KEYSTONE XL PIPELINE PROJECT

0262-SD-P4-477-8-478-2-1

KEYSTONE XL PIPELINE PROJECT ROUTE VARIATION AUTHORIZATION FORM		
Date: 3/19/2012	Tracking Number: 0262-SD-P4-477.8-478.2-1	MP: 477.8 to 478.2
Description: The primary reason for this reroute is to shift CL and workspaces further away from spillway/man-made pond to improve constructability and avoid integrity issues in the future. Reroute was field shot by civil survey.	Originated By: Engineering	Variation Form Attached: Yes <input checked="" type="checkbox"/> No <input type="checkbox"/>
TransCanada - Land Tina Hall	Variation: Approved <input checked="" type="checkbox"/> Rejected <input type="checkbox"/>	Date: 4-16-12
Comments:	If Rejected Why?	
TransCanada - Engineering Meera Kothari	Variation: Approved <input checked="" type="checkbox"/> Rejected <input type="checkbox"/>	Date: 3/20/12
Comments:	If Rejected Why?	
Exp - Engineering Butch Wallace	Variation: Approved <input checked="" type="checkbox"/> Rejected <input type="checkbox"/>	Date: 3/22/2012

Proposed Route Variation 0262-01

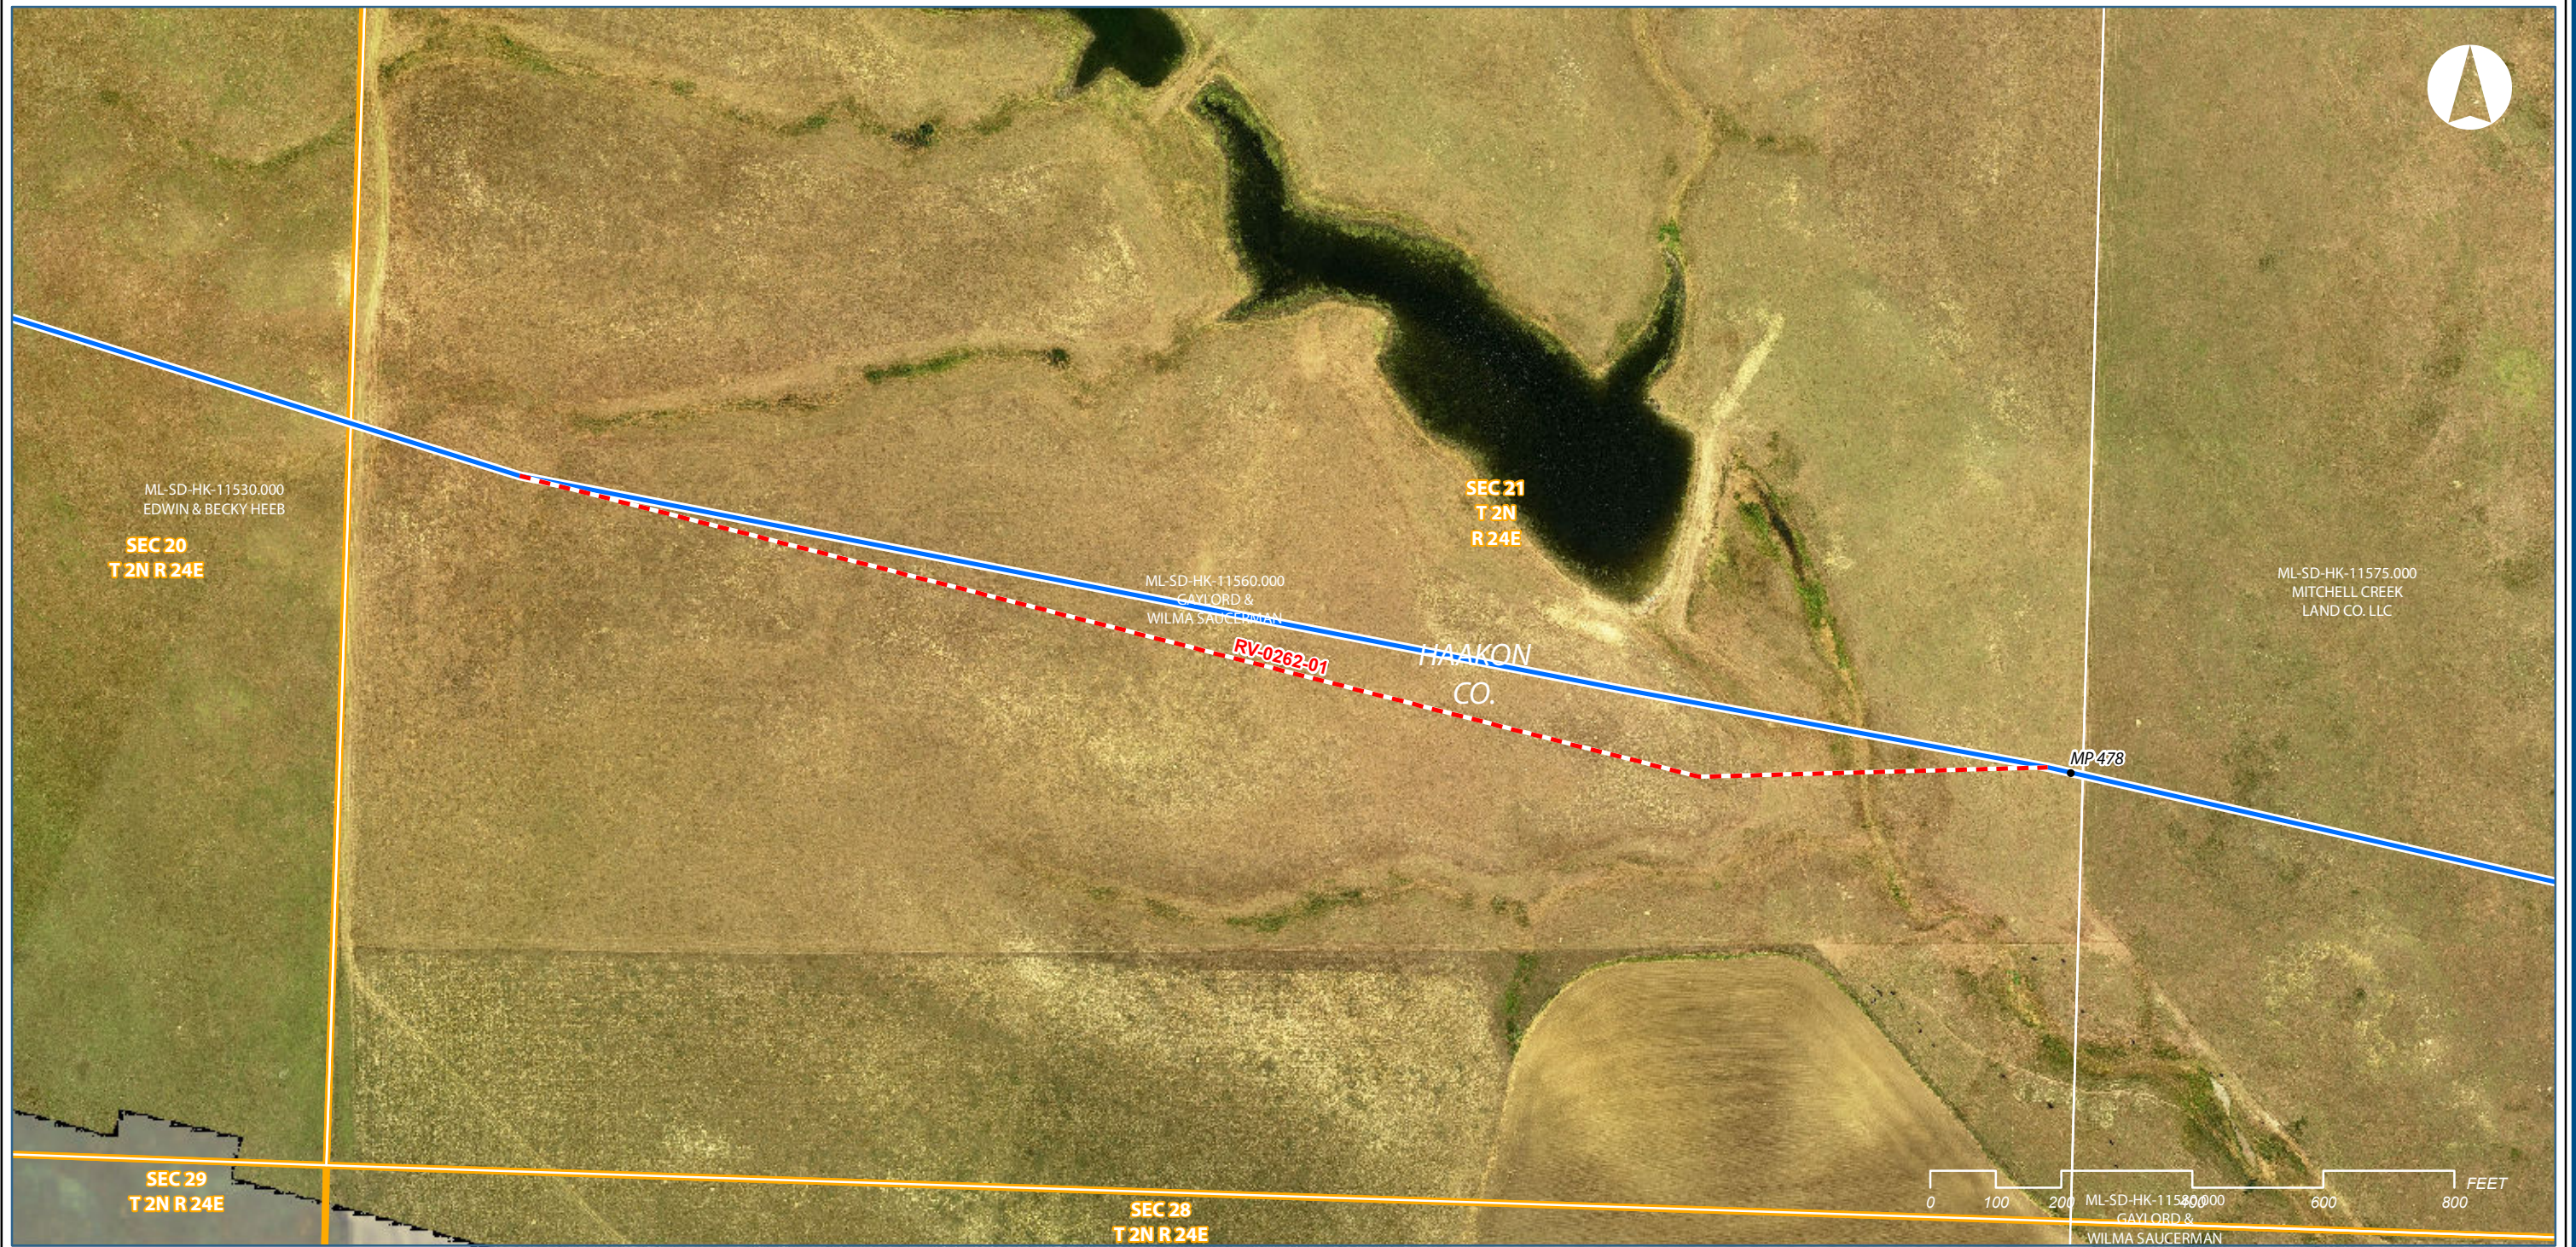
DETAIL ROUTE VARIATION (Please describe route variation in detail): Route variation starts near MP 477.7 and deviates ~3° southeast. It continues in this direction for ~1,858 ft. This allows more distance (~223 ft.) between CL/workspaces and spillway/man-made pond. Then the reroute turns northeast and extends for ~533 ft. before rejoining the C/L near MP 478.2.			
ADDITIONAL IMPACTS (Please include any additional impacts which may affect cost; crossings, induction bends, etc.): No New Landowners are impacted by this route variation. One tract is impacted by reroute: ML-SD-HK-11560.000 (Gaylord Saucerman & Wilma Saucerman). The reroute will allow construction savings (~\$15,000). As well as keep the integrity of the pipeline.			
Is there an increase/decrease in the number of crossings? Yes <input type="text"/> No <input checked="" type="checkbox"/>			
If yes, please list: <input type="text"/> <input type="text"/>

Comments:	If Rejected Why?	
Exp - Environmental Jonathan Minton	Variation: Approved <input checked="" type="checkbox"/> Rejected <input type="checkbox"/>	Date:
Comments: Pending Survey	If Rejected Why?	
Stantec - Risk Assessment Heidi Tillquist	Variation: Approved <input type="checkbox"/> Rejected <input type="checkbox"/>	Date:
Comments:	If Rejected Why?	
Facilities - TransCanada Sandra Gigovic	Variation: Approved <input type="checkbox"/> Rejected <input type="checkbox"/>	Date:
Comments:	If Rejected Why?	
TransCanada - PM (Montana) Alan Lietz	Variation: Approved <input type="checkbox"/> Rejected <input type="checkbox"/>	Date:
Comments:	If Rejected Why?	
TransCanada - PM (South Dakota) James Odom	Variation: Approved <input checked="" type="checkbox"/> Rejected <input type="checkbox"/>	Date: 5/23/12
Comments:	If Rejected Why?	
TransCanada - PM (Nebraska) Robert Bradley	Variation: Approved <input type="checkbox"/> Rejected <input type="checkbox"/>	Date:

Comments:	If Rejected Why?	
TransCanada - Keystone XL Manager Steve Marr	Variation: Approved <input checked="" type="checkbox"/> Rejected <input type="checkbox"/>	Date: Jun 15/12
Comments:	If Rejected Why?	
Forward to: Tina Hall <input type="checkbox"/> Meera Kothari <input type="checkbox"/> Butch Wallace <input type="checkbox"/>	Jonathan Minton <input type="checkbox"/> Heidi Tillquist <input type="checkbox"/> Sandra Gigovic <input type="checkbox"/> Alan Lietz <input type="checkbox"/>	James Odom <input type="checkbox"/> Robert Bradley <input type="checkbox"/> Steve Marr <input type="checkbox"/>
